Planning &
Environment

***TRANSITIONAL PART 3A PROJECT
ASSESSMENT***

**Section 75W Modification Request
DEXUS Industrial Estate, Greystanes
Southern Employment Lands, Holroyd
Local Government Area
(MP08_0259 MOD 6)**

Secretary's
Environmental Assessment Report
Section 75W of the
Environmental Planning and Assessment Act 1979

Figure 3: Proposed DEXUS Estate masterplan - Super lot A MOD 6

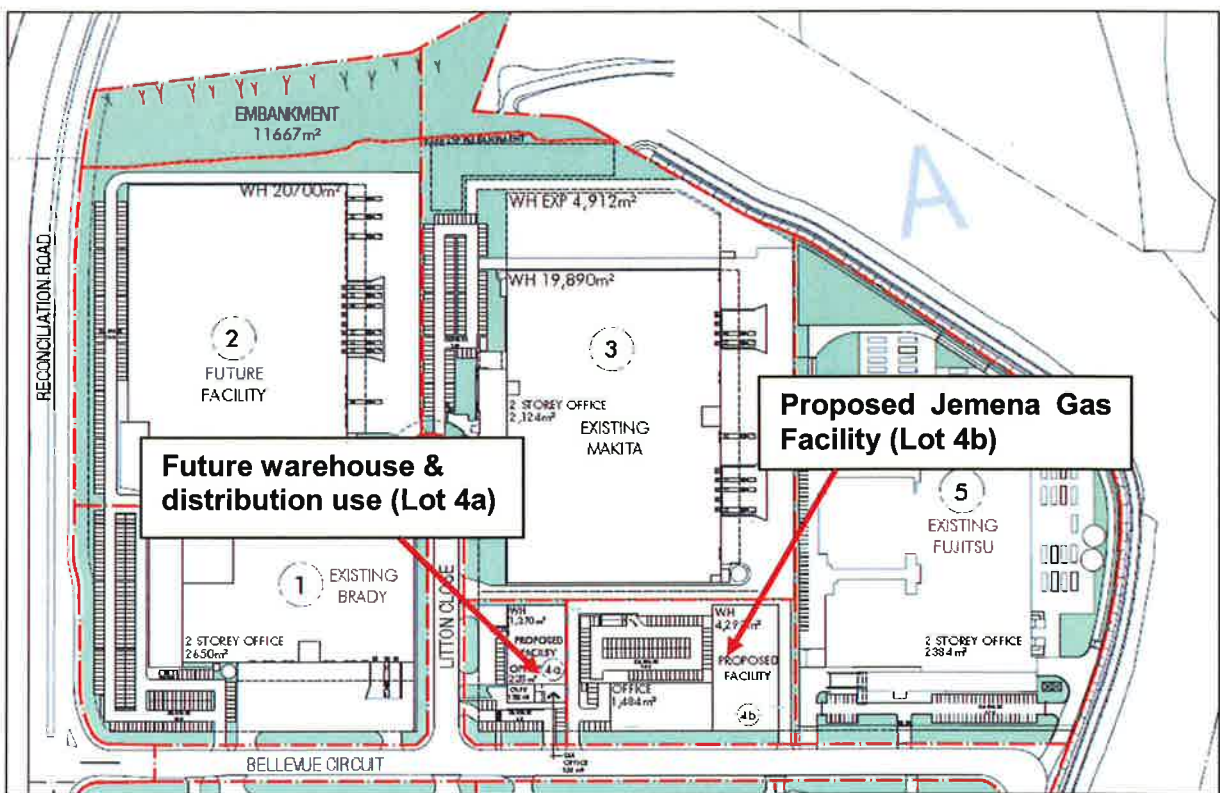
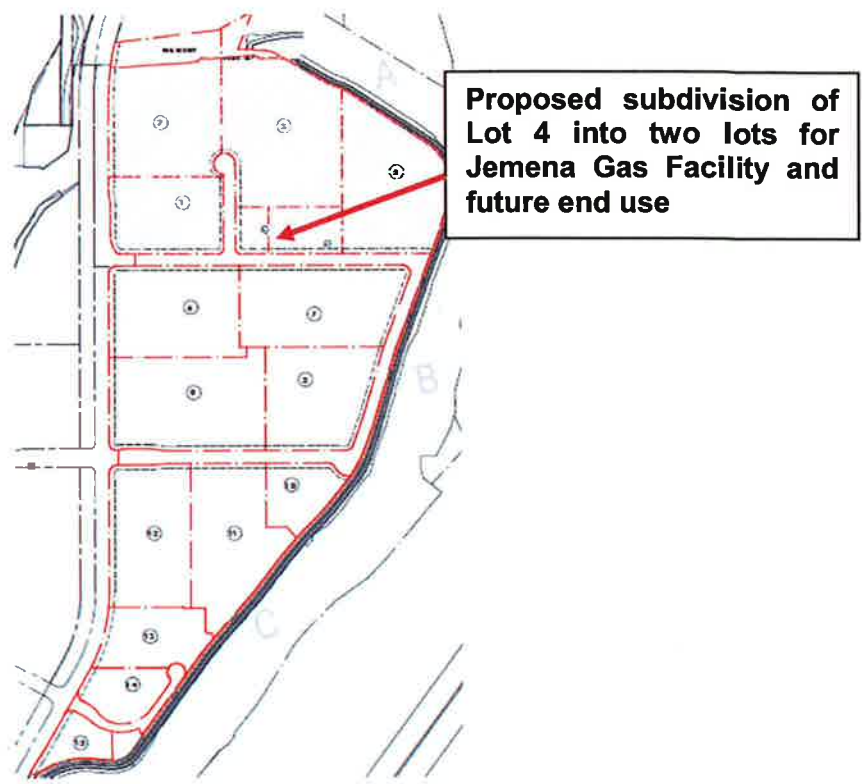
- subdivision of Lot 4 into two lots to enable the establishment of a facility for Jemena (on proposed Lot 4b) and a future warehouse/distribution use (on proposed Lot 4a) (**Figures 3 and 4**);
- relocation of an approved estate manager's office and cafe from super lot C to proposed Lot 4a; and
- minor "housekeeping" changes to the super lot C master plan and updated development data for super lot A to reflect previously approved modifications.

The proposed subdivision of approved Lot 4, super lot A to create Lots 4a and 4b (resulting in 16 lots instead of 15 lots for the estate) will result in two smaller lots to accommodate two proportionately smaller facilities of a similar height and scale to the one approved building (the Voith Turbo Facility previously approved for Lot 4 in MOD 3). This is unlikely to result in any adverse impacts on the design quality of the project or visual amenity of the locality. It will generally improve the visual amenity of the estate, as it will facilitate two smaller scale buildings facing Bellevue Circuit rather than one larger building in the original approved layout. This will generally assist in reducing the scale and bulk of the facilities when viewed from this elevation.

The Department considers the revised subdivision layout for super lots A and C is generally consistent with the project approval, will have minimal environmental impacts and is recommended for approval.

Figure 6: Vehicular access to Lots 4a and 4b on Bellevue Circuit and Litton Close

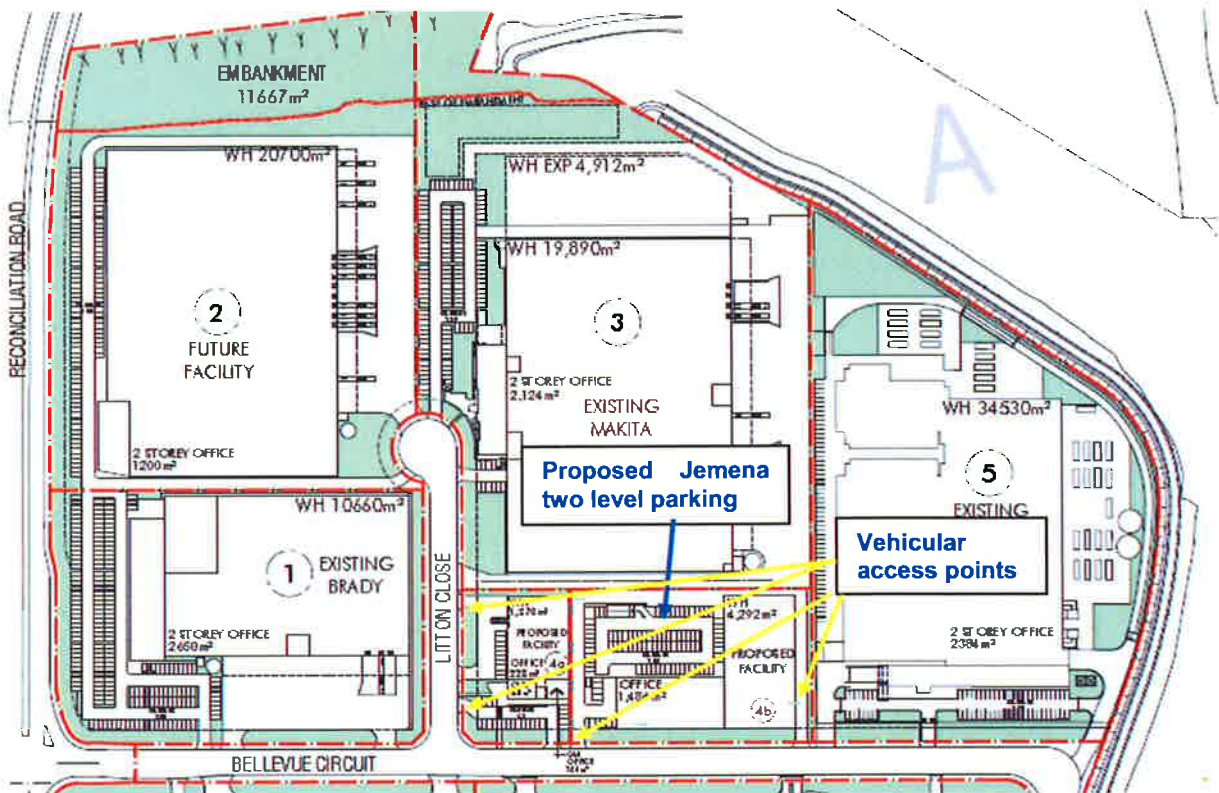
Council's submission considered that a traffic assessment is required to confirm that overall traffic generation from the DEXUS Estate will not increase. Council also commented on the shortfall of parking spaces for the training component of the proposed Jemena facility.

Council noted that there is no specific parking rate in the DCP for the training component and that the closest applicable parking rate is 'information and education facility' which it applied in its calculations. Council also acknowledged that applicants can undertake parking surveys for similar sites to determine an appropriate parking rate on a site specific basis.

The parking rate for 'information and education facility' does not apply to the Jemena facility which is properly categorised as a light industrial/warehouse/distribution land-use. The proposed parking provision is based on the expected worst-case demand for Jemena with up to 70 staff and 60 trainees (at any one time). The proposed 152 parking spaces will comfortably accommodate the expected demand with some additional capacity for parking of Jemena-owned vehicles.

The Department does not agree with Council's comment that a traffic assessment is required. A comprehensive traffic assessment was undertaken for the original project approval. The predicted traffic generation for MOD 6 is less than that assumed in the original assessment due to a proposed reduction in the total building area for the project approval. MOD 6 will generate a need for 21 fewer on-site car parking spaces but will provide 117 spaces in excess of the minimum requirement to cater for Jemena's staffing levels and fleet vehicles. Application of an 'information and education facility' parking rate to Jemena's training component is unwarranted as it will be ancillary to the dominant warehouse/distribution use. Accordingly, another traffic assessment is unnecessary.

Vehicular access to the car park for all components of the Jemena facility will be via the western access off Bellevue Circuit (**Figure 6** above). Vehicles accessing the office and training components will also exit the site on that driveway whilst vehicles servicing the warehouse component will exit the site from the eastern driveway off Bellevue Circuit.
